EDGE-ON-HUDSON

APPLICATION FOR SITE PLAN & SUBDIVISION APPROVAL

PHASE ONE SUPPLEMENTAL SUBMISSION 2

Re: Phase 1 Site Plan and Subdivision Application
Edge-On-Hudson Riverfront Development
199 Beekman Avenue, Sleepy Hollow

● **Street Fixture (14' Height)**
Company: Louis Poulsen
Model: Kastrup
Color: Black Powder Coat Finish

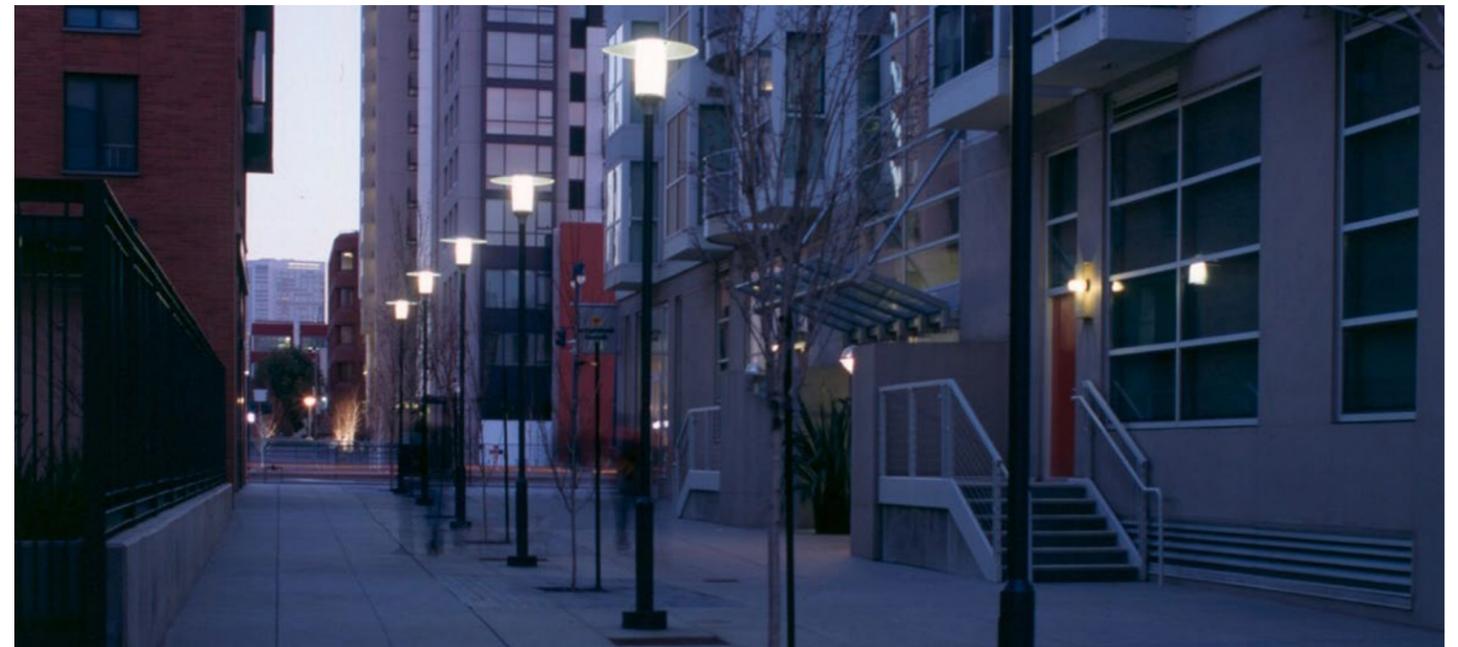
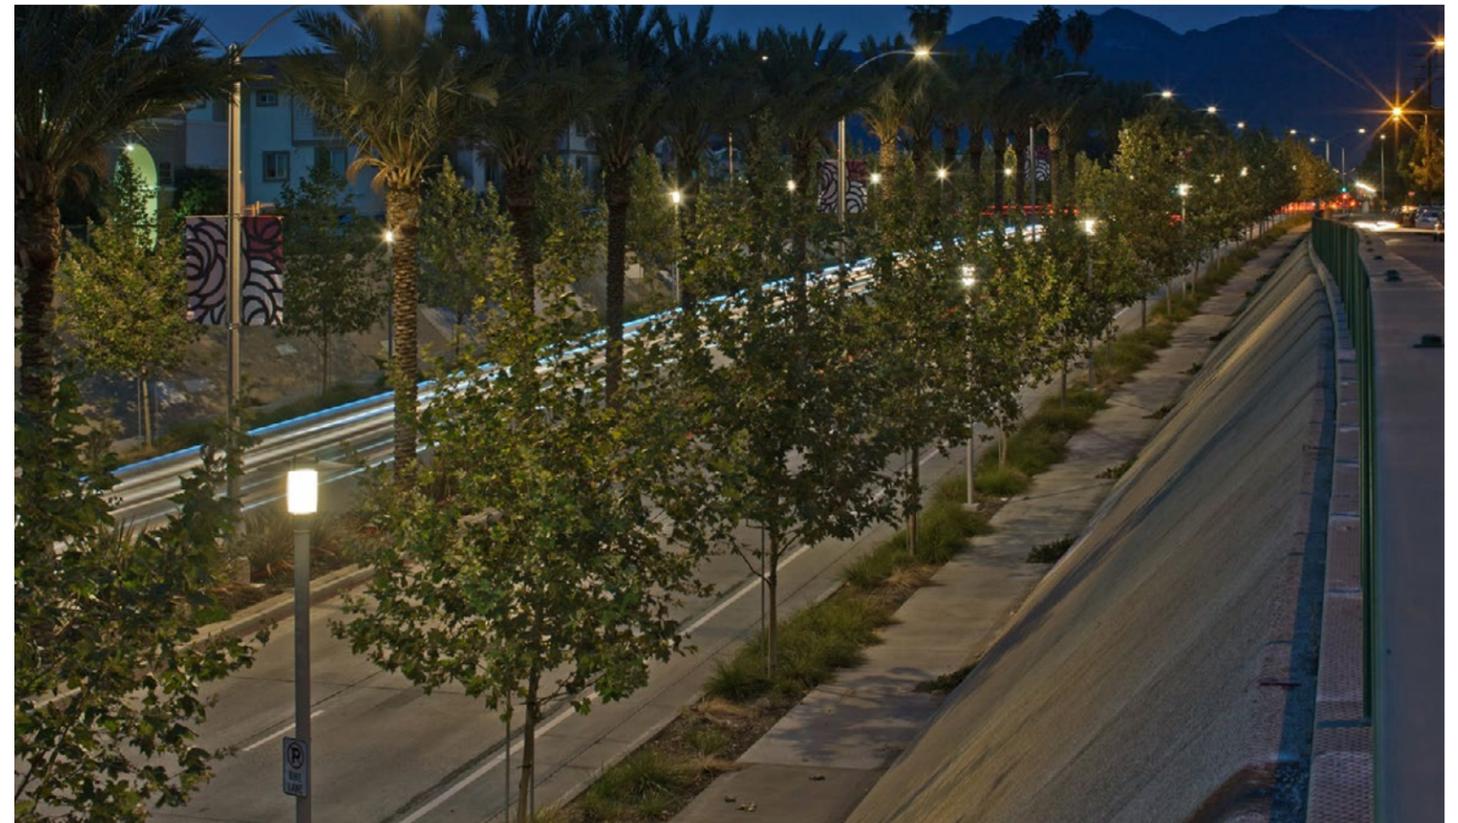
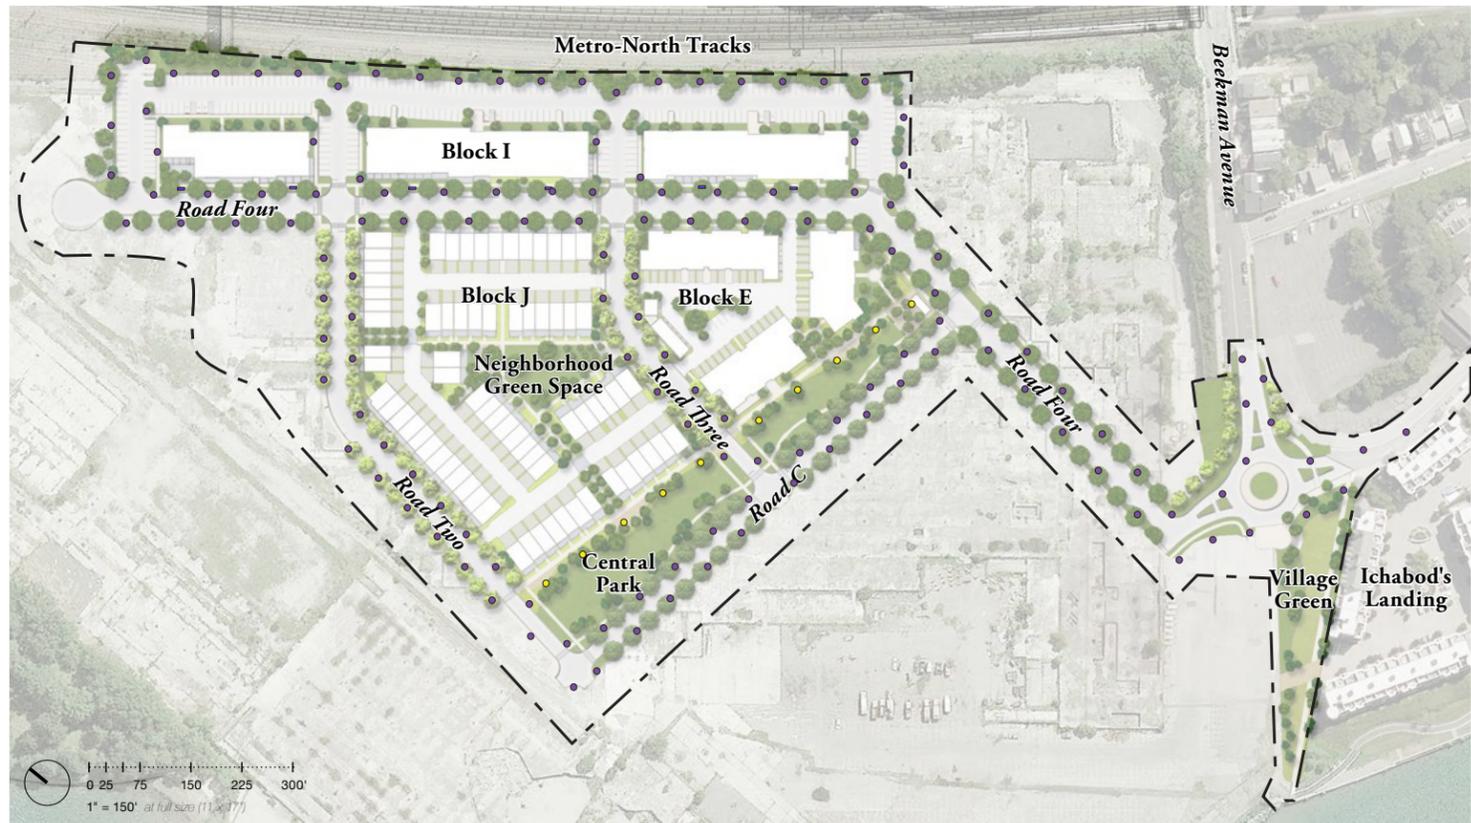
9. **Comment:** *The lighting fixture suggested by the Applicant appears to be consistent with the example provided in the design guidelines. Is there a reasonably nearby development in the Metropolitan area where it has been used?*

- Response:** A list of locations where the proposed Louis Poulsen fixture has been installed is provided at the end of Exhibit 1, Landscape Architecture. The closest installation is along the streets of Westchester's Ridge Hill, located in Yonkers, New York.
